1412 E. ROBINSON ST. MALLEN OFFICE FRONT PARKING

SUMMARY

<p>Applicant/Owner David Mallen SLM2, LLC</p> <p>Project Planner Jim Burnett, AICP</p> <p>Updated: November 16, 2015</p>	<p>Property Location: 1412 E. Robinson St. (Parcel ID #25-22-29-1012-01-090, on the south side of E. Robinson St., between Shine and N. Fern Creek Aves.)(±0.15 acres, District 4).</p> <p>Applicant's Request: The applicant is requesting several parking-related variances as a result of a code enforcement complaint on an existing professional office in the O-1/T zoning district, as follows:</p> <ul style="list-style-type: none"> A. Design Variance to allow accessory parking between the front lot line and the principal building facade; B. Variance to allow pavers as an alternative durable all-weather surface for the two (2) requested front parking spaces; C. Variance to allow 52% front yard impervious 	<p>surface coverage, where limited to 40%; and</p> <p>D. Design Variance to allow a post & panel sign in the Traditional City Overlay.</p> <p>Staff's Recommendation: Approval of Design Variances A and D and Variances B and C, per the conditions in the staff report.</p> <p>Public Comment Courtesy notices were ma

Google photo of site.

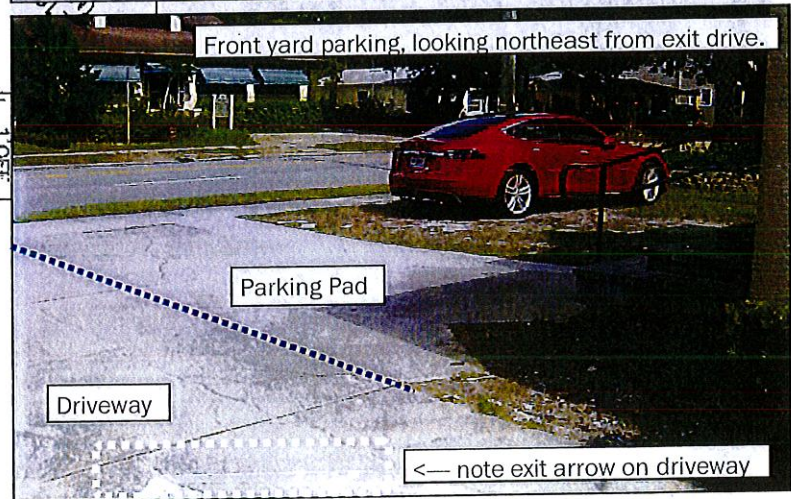
← note exit arrow on driveway

SITE PHOTOS

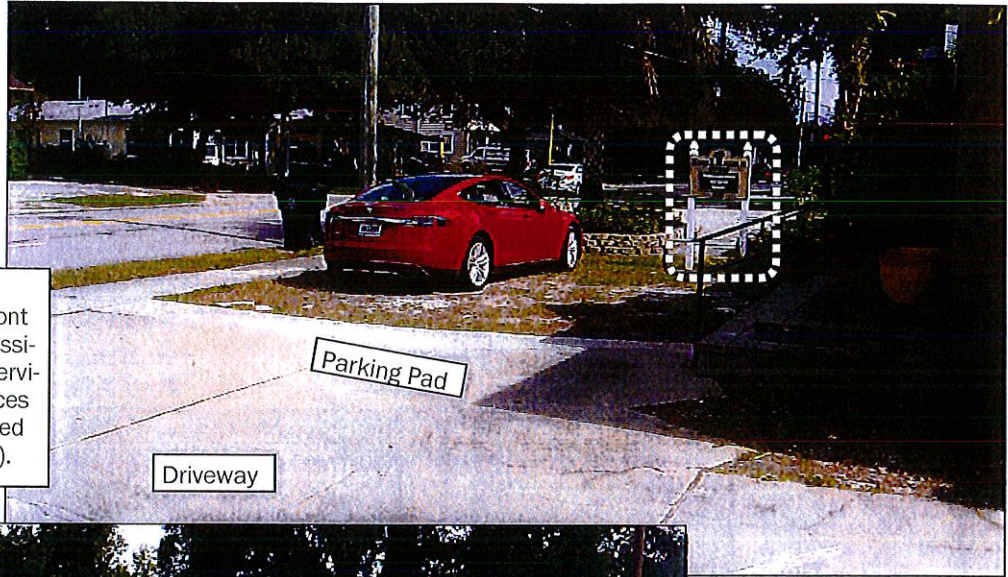
Front parking and drive aisle. Variances needed to retain front parking, use of pavers and possible increase in front yard impervious surface coverage (Variances A, B & C). Also note unpermitted post & panel sign (Variance D).

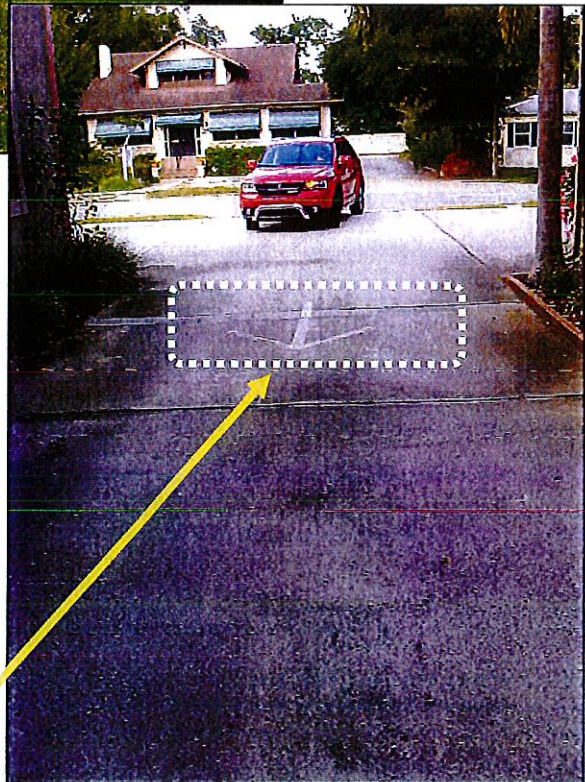
View of rear gravel and grass parking area for subject property, with access from adjacent offices to the east.

Driveway for office to the east (1416-1420 E. Robinson St.), with arrow pointing inward (south), with exiting driveway to the west on subject property (1412 E. Robinson St.).

not taking away lot parking - work w. neighbor to fix adj. lot

OWNER-PROVIDED SITE PLAN

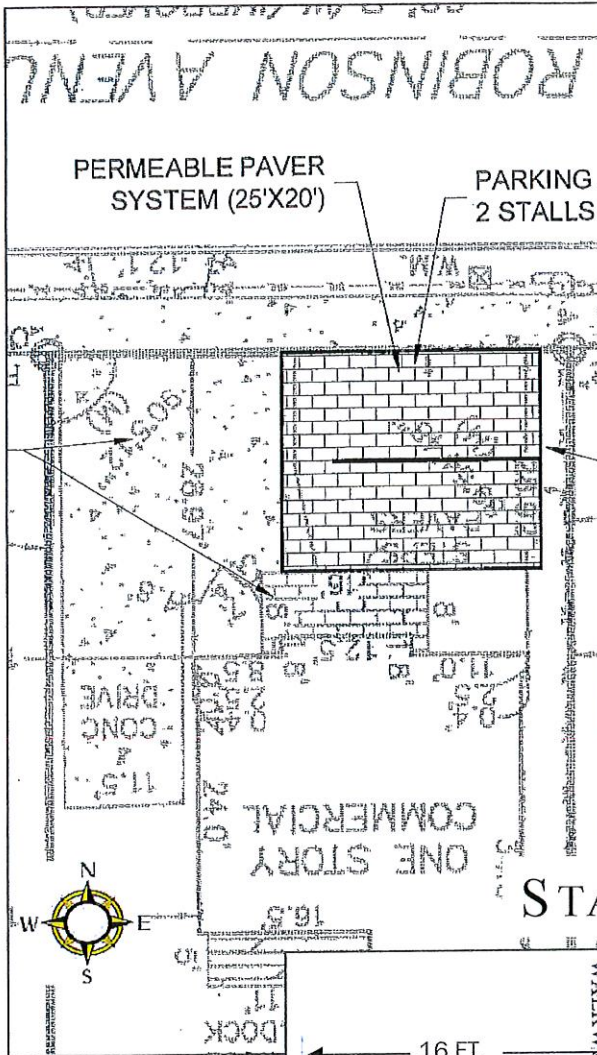
Owner-suggested site plan provides no buffer between two (2) front parking spaces and front lot line, and very little buffer between spaces and east lot line.

STAFF-PREFERRED SITE PLAN

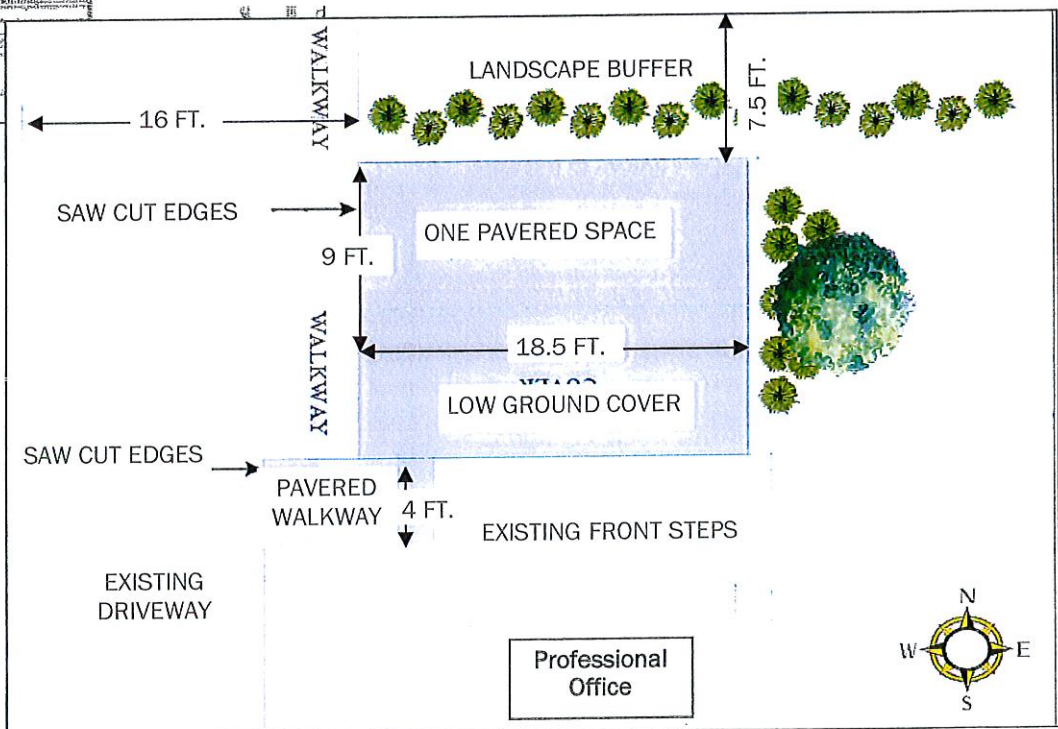
DESIGN VARIANCE A - Parking in front of building in Traditional City Overlay.

VARIANCE B - Allow use of pervious pavers in lieu of durable all-weather driving and parking surface in front parking space(s).

(3rd variance needed for front yard impervious surface coverage if front space is impervious).

Staff Recommendation: **Approval of one (1) space only**, with minimum 7.5 ft. landscape buffer between parking space and front lot line and between parking space and east lot line, with groundcover or grass between the parking space and the front steps.

Staff Recommendation: **Approval**, with installation of pervious pavers for the **one front parking space**.
